# Baldy Area, Mt Buller Ski Field, Mt Buller

Officer Assessment Report  
Development Approvals & Design

Department  
of Transport  
and Planning

Figure 1: Existing conditions of building, includes the rocks to be removed (Source: Application)

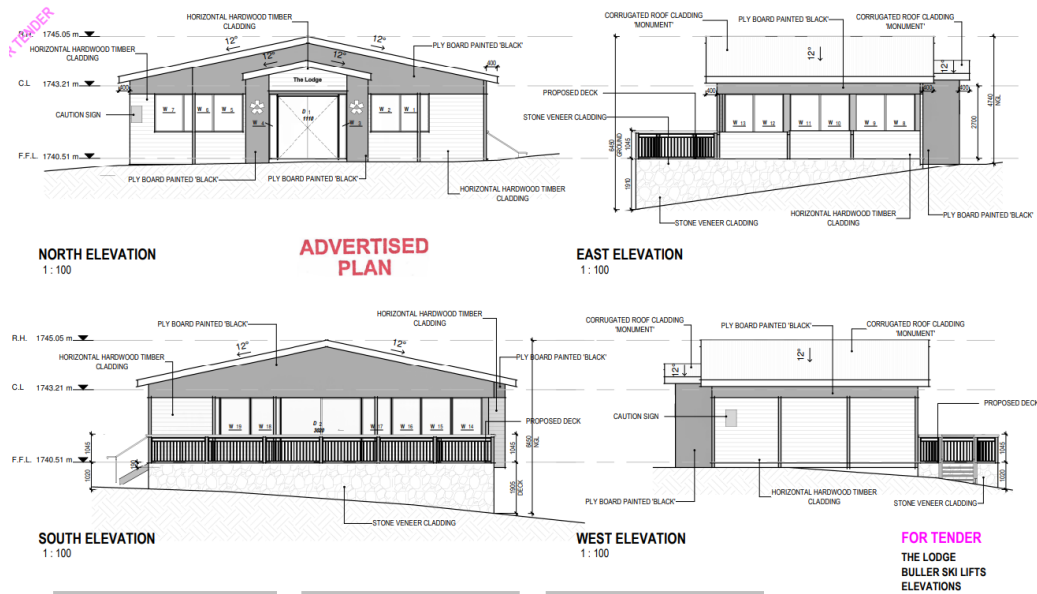
71. The existing conditions include rock beaching around the perimeter of the existing building. This was a knee jerk response by BSL staff to address the stonework requirement of the DDO at the time BSL made a request to amend the permit so that the building could be permanent. A condition of the permit will require that the existing rock beaching be removed prior to the commencement of the development.

Figure 2: Proposed elevations (Source: Application)

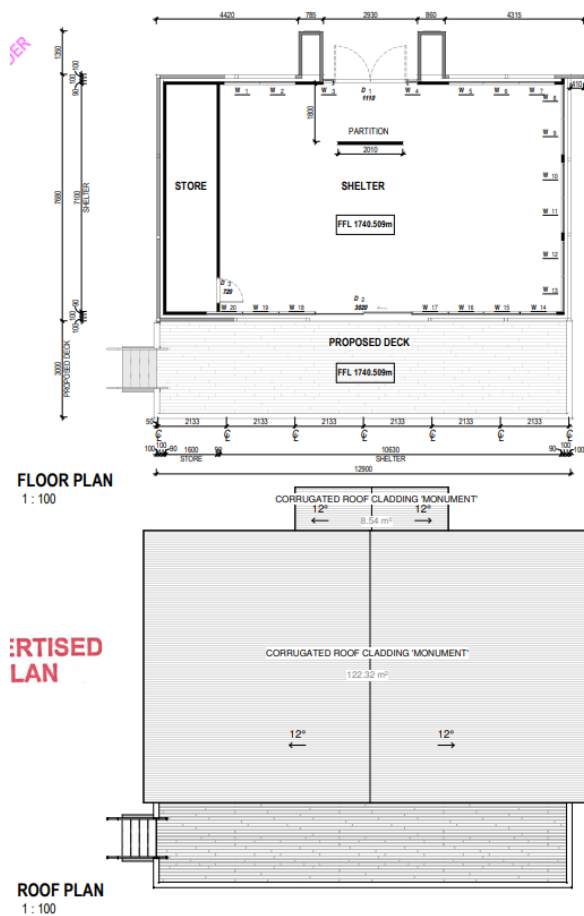
68. In terms of wall and roof materials, the building incorporates a Colorbond roof in 'Monument' colour (dark tone). This is consistent with the DDO3 requirements. For wall cladding, the building incorporates a combination of stone veneer cladding (brown tones), horizontal hardwood timber cladding (grey tones) and ply board (black colour), which are generally consistent with the DDO3 wall material requirements specified. However, the CFA, as a statutory determining referral authority, had requested further information to appropriately address the BMO requirements. This resulted in the wall cladding materials needing to be modified in order to obtain a BAL 40 rating. The applicant therefore submitted revised architectural plans (prepared by Taylor Design Group as Revision 10 and dated 12 April 2024) to satisfy the CFA requirements. The changes to the plans submitted to the CFA include:

- Deletion of the wall cladding 'ply board' and horizontal hardwood timber' and replacement with Colorbond 'Night Sky' and 'Woodland Grey'.
  - A notation on the plans to state that the building will be constructed to a BAL 40.

70. Importantly, it should be noted that the design of the building in this application will be modified from its existing form to now include stone into the wall of three of the four elevations. The inclusion of the stonework into the bottom part of the wall will remove the view of the pillars on which the building sits upon. The building will present as a permanent building rather than as a temporary one, ensuring it is consistent with other buildings within the alpine environment. The inclusion of the stonework, together with the Colorbond cladding, will ensure the building is constructed to achieve long lasting durability and able to withstand the harsh alpine weather and conditions in the alpine conditions all year round, therefore making the materials suitable and consistent with the objectives and the decision guidelines of the DDO3.

69. The CFA accepted the change in the materials. Therefore, to ensure that the revised architectural plans that the CFA reviewed are endorsed as part of the permit, a condition of permit will require the revised plans be submitted for approval that specifically include the changes to the materials. While the plans have been received by the applicant specifically to address the CFA requirements, they were not formally substituted, therefore the condition needs to be included in the permit to acknowledge that the revised plans will replace the advertised plans as the approved plans. The revised plans will be endorsed at the same time the permit is issued.

Figure 7: Area of previously significantly disturbed ground (Source: Application)

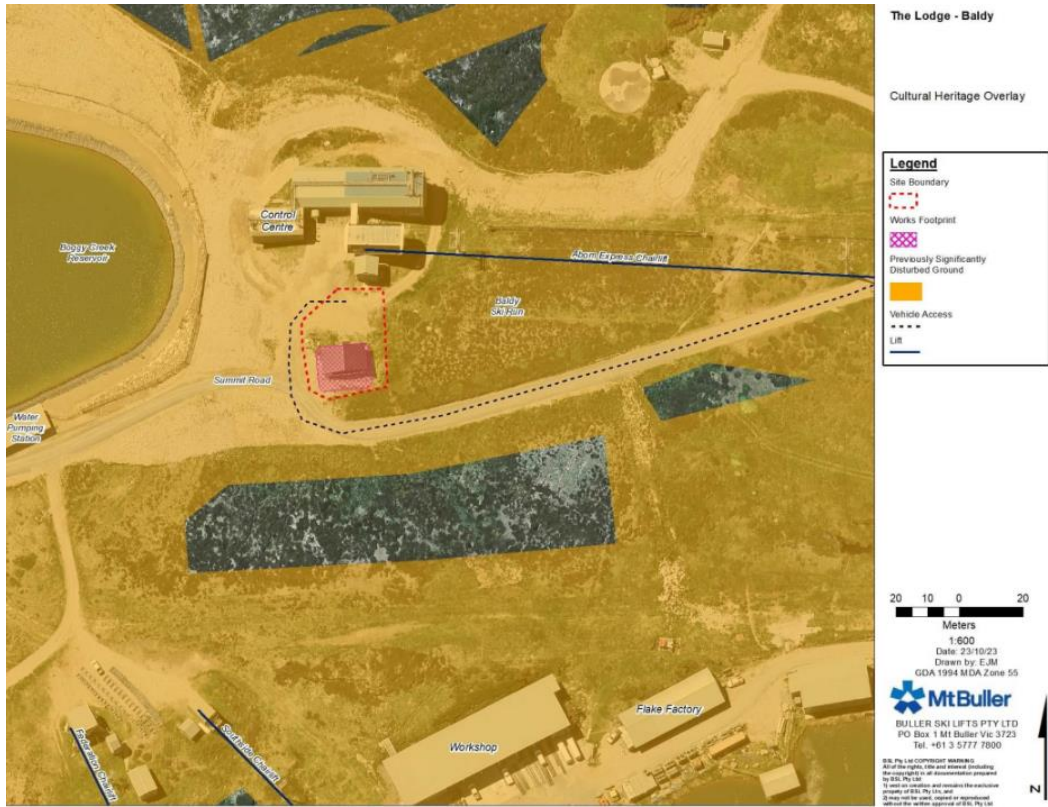
86. The development site is in an area which was previously disturbed and therefore a CHMP is not required to be submitted. The applicant has advised that the site has previously been subject to significant ground disturbance with the construction of the Baldy Duplex Poma ski lifts in 1969, the ski run (and road access) as part of that and subsequently the installation of the Baldy Double Chairlift in 1973, the Helicopter Flat Triple Chairlift (Abom Chairlift) in 1986 and the Mercedes Six-Seater Chairlift in 2008. The proposed building is in the same location as where the top/drive station of the Helicopter Flat Triple Chairlift was located and is resting on some of the original concrete footings and pads. Accordingly, it is considered that significant ground disturbance has occurred, and a cultural heritage management plan is not required.

87. A map was provided that shows the areas of previously disturbed ground. (Refer to Figure 7).
